UT to Magness Creek Mitigation Project Mitigation Plan – Final

Re: NCIRT Review and USACE Approval of the NCDMS UT to Magness Creek Mitigation Site / Cleveland Co./ SAW-2018-01759/ NCDMS Project # 100081

Subject: Response to IRT Comments for Final Draft Mitigation Plan review UT to Magness Creek Mitigation Project, Cleveland County, Broad River Basin, CU# 03050105, DMS Project #100081, DEQ Contract #7604, USACE #SAW-2018-01759

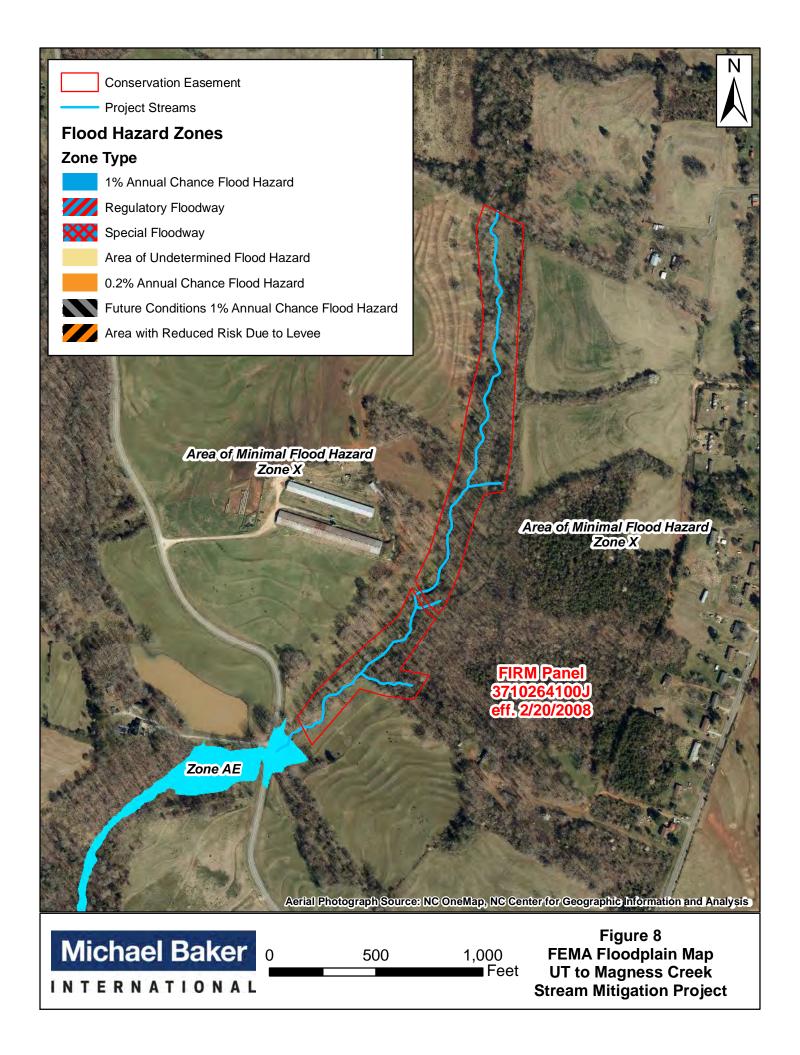
5. Figure 4 – Please show the location of the pre-construction groundwater well mentioned in DMS' comments. DWR is interested to review available data included in the Final Mit Plan. **Response: The location of the pre-construction groundwater wells were added to Figure 4 as requested, while the well data is provided in Appendix A.**

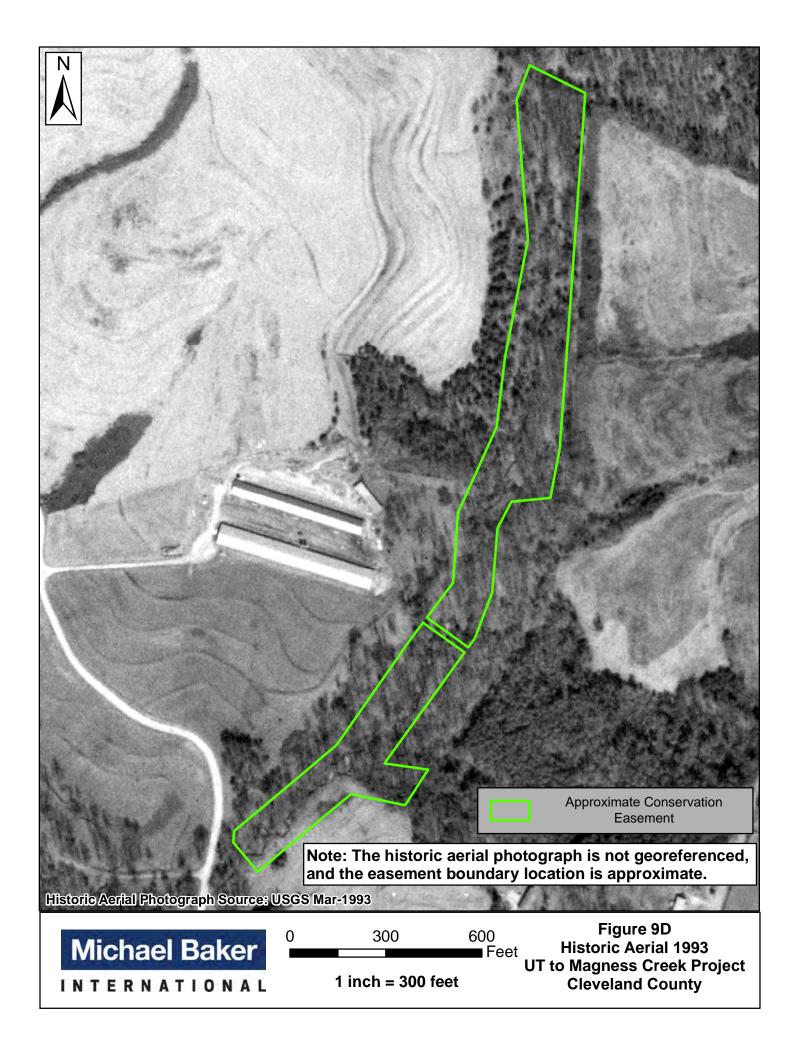
2. Figure 11 and Section 6.5.1: It's noted in Section 3.2.3 that Wetlands F, E and D are not proposed for credit generation. If you anticipate that these wetlands may be needed to meet contract amounts should other parts of the site not meet success, please monitor these areas so data is available, if needed.

3. Figure 11: Please ensure that the portion of stream that runs through the crossing is shown as "not for credit" on the figure.

4. Figures 11 & 12: Please label the three wetland re-establishment polygons for clarity. **Response: Figures revised as requested.**

Response: Absolutely. If it is ever even a consideration that these wetlands might ultimately be needed for credits Baker will quickly begin monitoring them using appropriate measures.

Response: Figure 11 was revised as requested, though Figure 12 is the formal Project Asset and Credit Map and shows that section of stream within the crossing as being 'not for credit' as do the plan sheets and the digital files.
